P 535184
A REPAIR

Septic Repair ON-SITE SEWAGE DISPOSAL SYSTEM HOWARD COUNTY HEALTH DEPARTMENT BUREAU OF ENVIRONMENTAL HEALTH

ADDRESS: 13258 Hunt Ridge Road PROPERTY OWNER: Jeff Willey

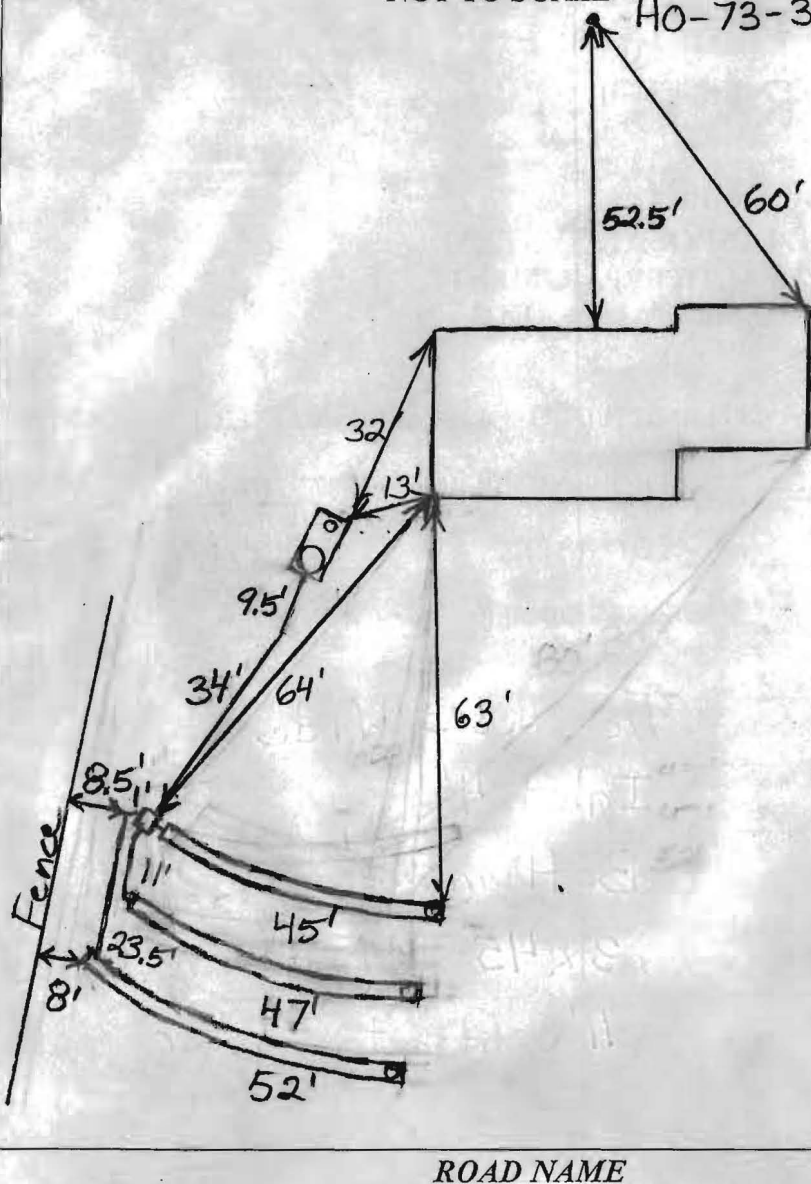
5/13/2011 Place the distribution box about 7' from the right property line. I install three 45' trenches on contour just below the evergreens. BB

5/16/2011 System finished, O.K. to backfill. BB
